Subject: **Palo Verde Nuclear Generating Station Unit 3
Docket No. STN 50-530
Core Operating Limits Report, Revision 26**

**PVNGS Unit 3 Core Operating Limits Report
Revision 26**

Revision 26

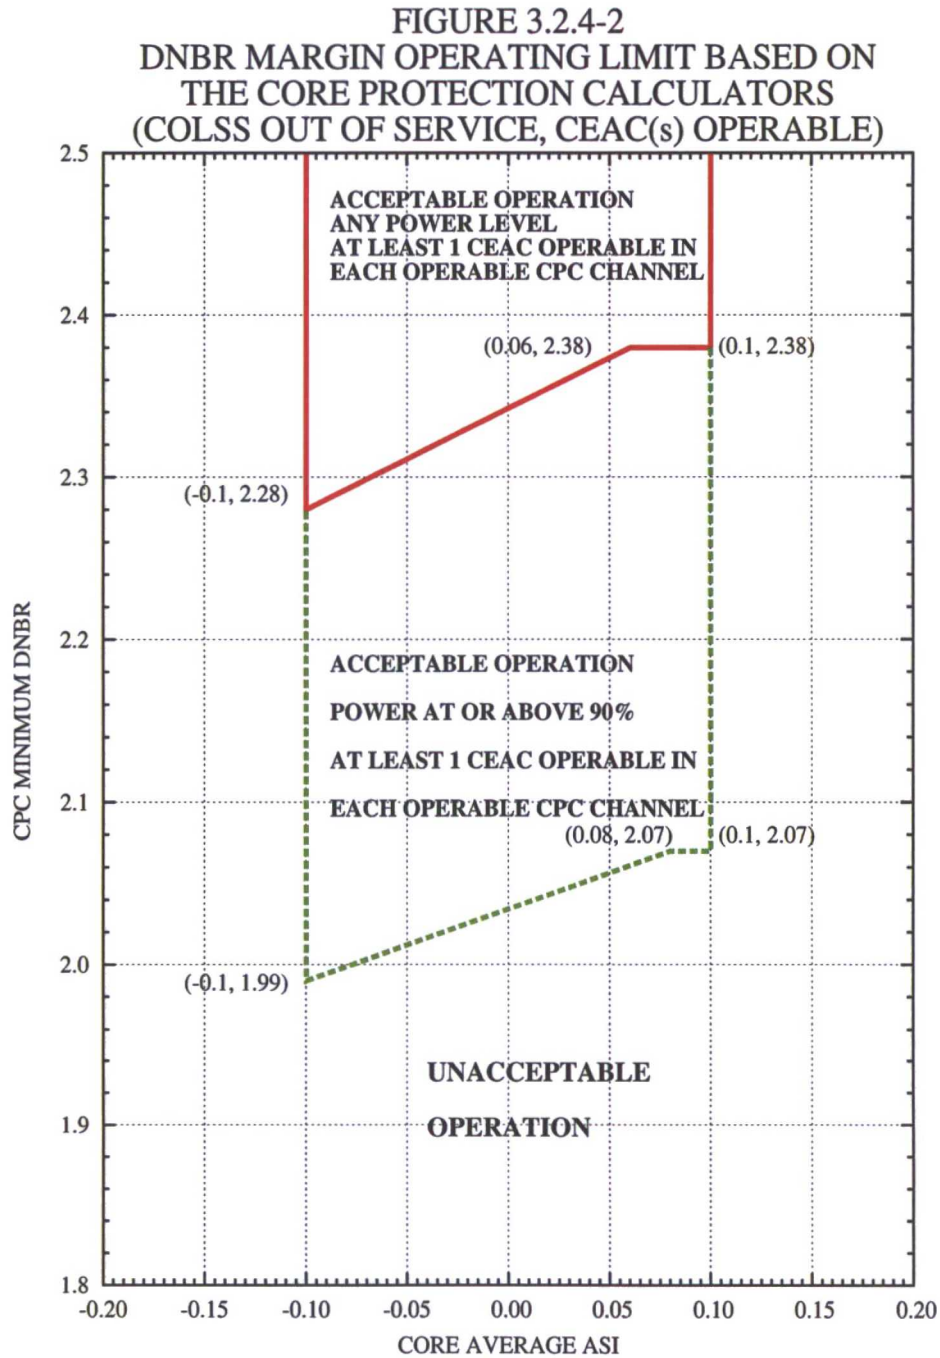
Pursuant to Palo Verde Nuclear Generating Station (PVNGS) Technical Specifications, Section 5.6.5.d, enclosed is the Unit 3 Core Operating Limits Report, Revision 26, which was made effective October 23, 2019. Figure 3.2.4-2 was updated in this revision. A revision bar has been applied to the change.

COLSS OUT OF SERVICE and CEAC(s) OPERABLE - Operate within the region of acceptable operation of Figure 3.2.4-2 using any operable CPC channel.
